**PC Case 20-10 – Site Plan Review for the Expansion of an Existing Building at 1700
Marthaler Lane – Maureen Haggerty**

To: **Planning Commission**
From: **Melissa Sonnek, City Planner**
Date: **September 15, 2020**

Case 20-10 – Site Plan Review for the Expansion of an Existing Building at 1700 Marthaler Ln – Maureen Haggerty

SHEET NUMBER: 110

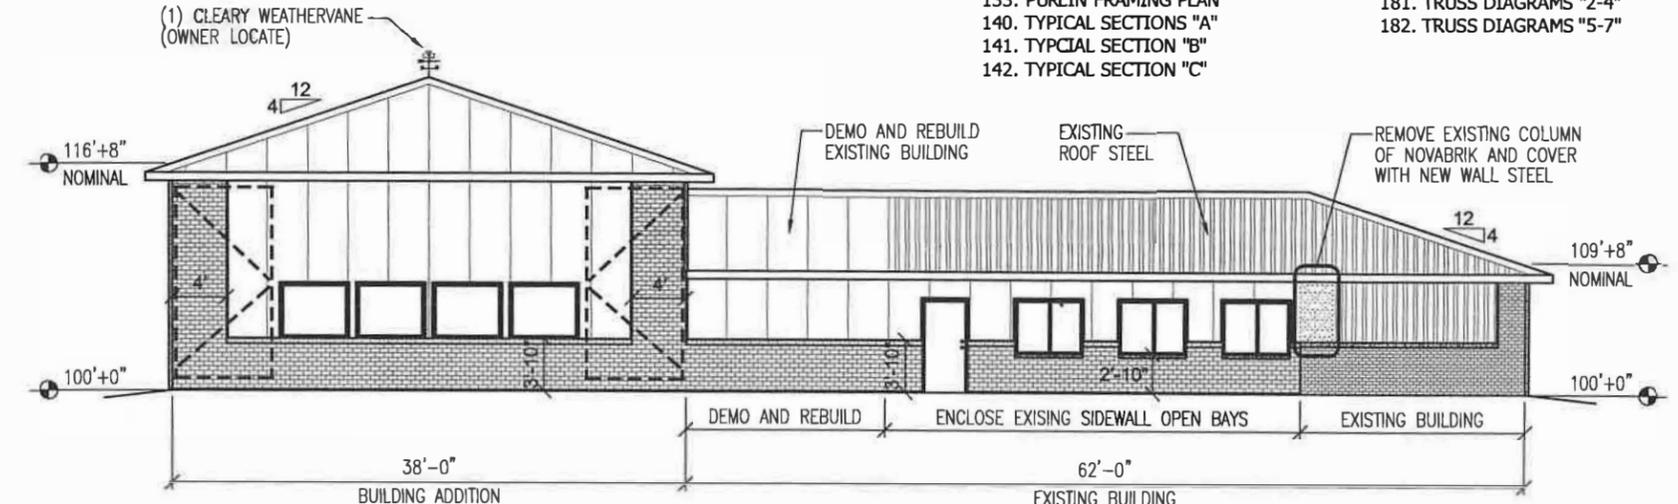
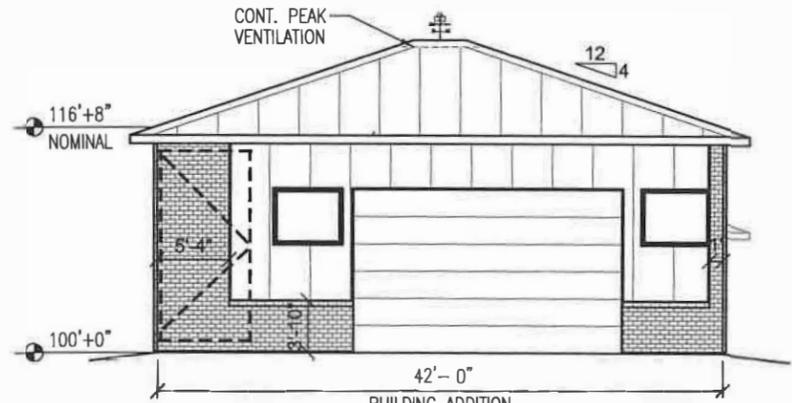
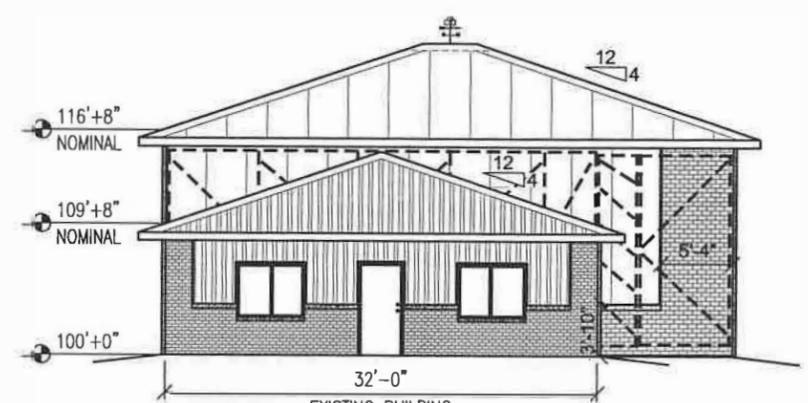
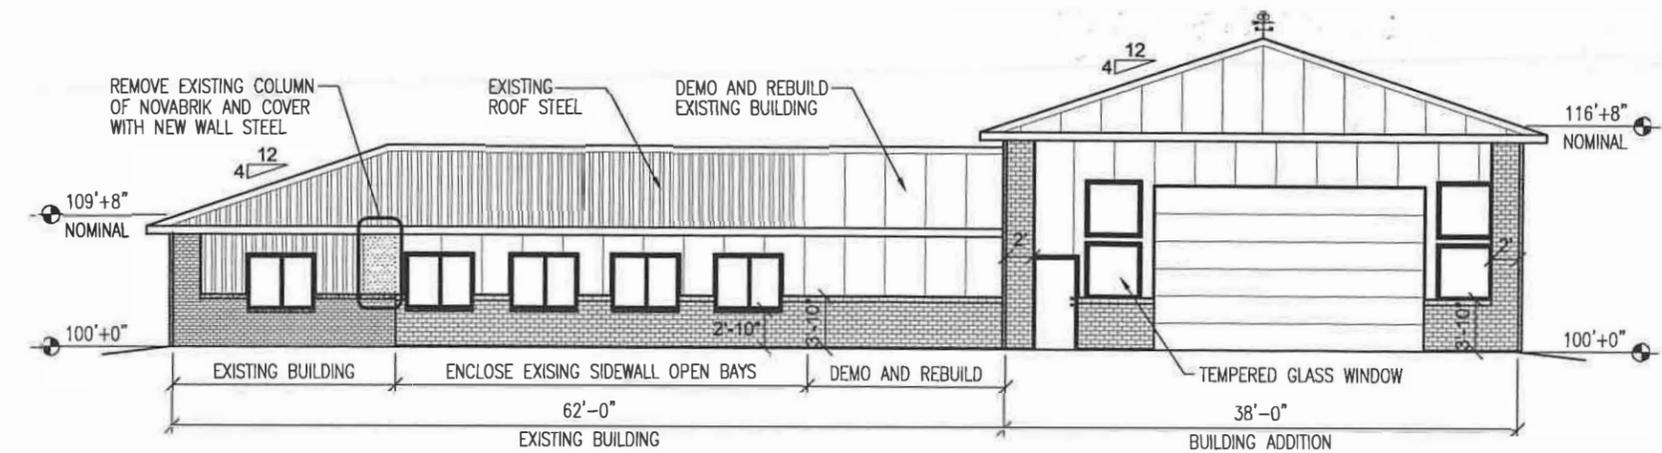
West (Front) Building Elevation

The code also requires visual relief for any building walls that are longer than 60 ft. in length, both the north and south elevations have walls that stretch longer than 60ft. The visual relief requirement can be met by incorporating two of the following items:

PROJECT NUMBER: **2020100379**
SHEET NUMBER: **111**
SHEET SCALE: NONE

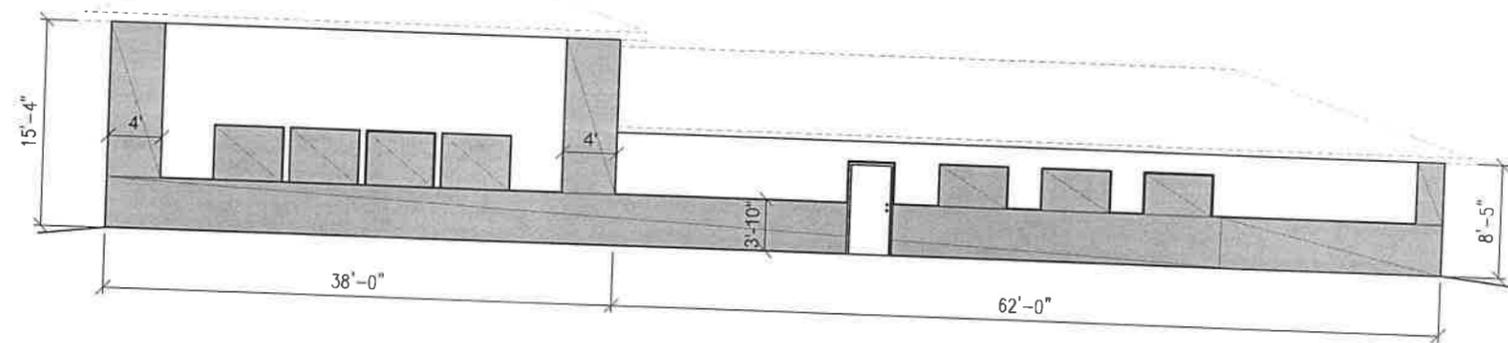
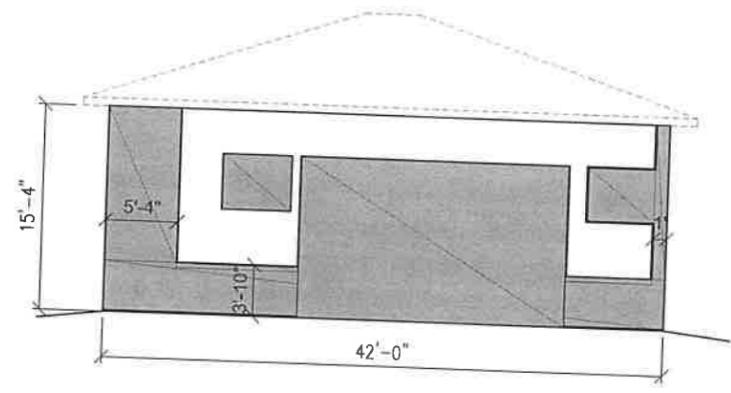
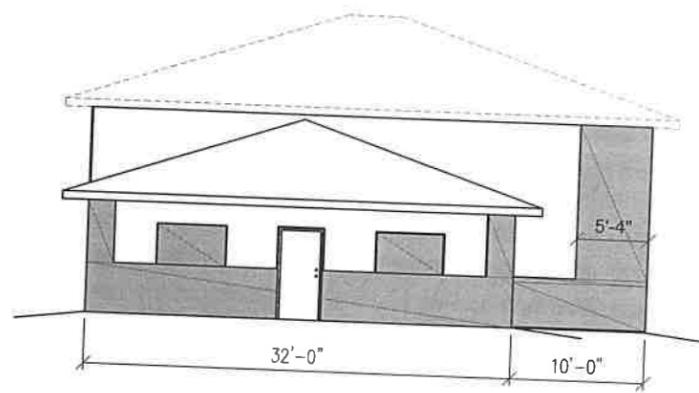
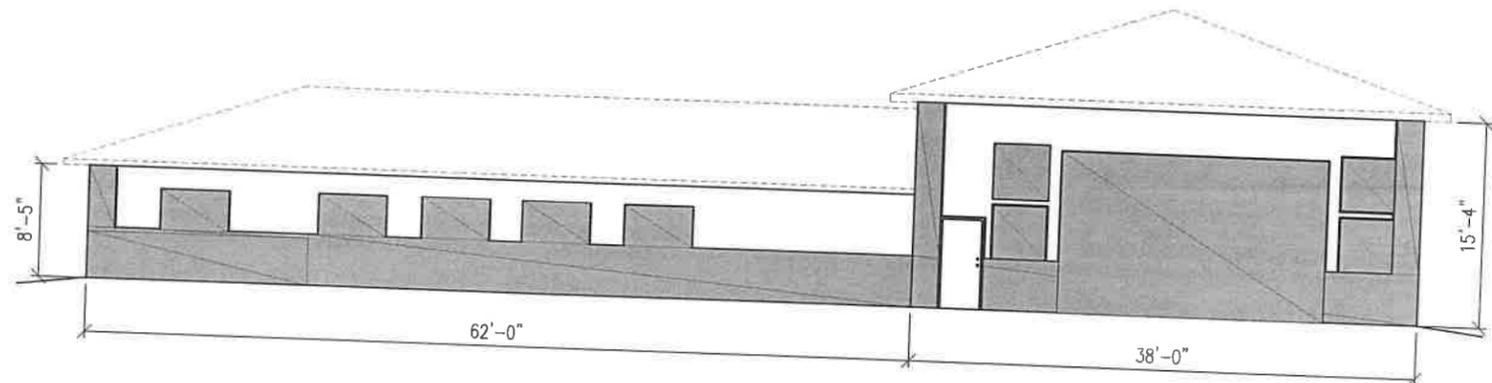
Code requires that at least 60% of a building be primary materials, such as stucco, brick, glass, or other comparable material; and that no more than 40% per comprised of secondary materials such as colored block, composite wood, or metal paneling. The applicant is proposing a combination of brick (primary), glass (primary), and metal (secondary).

City Staff is recommending as a condition of approval that the applicant incorporate visual relief measures to the north and south elevations.
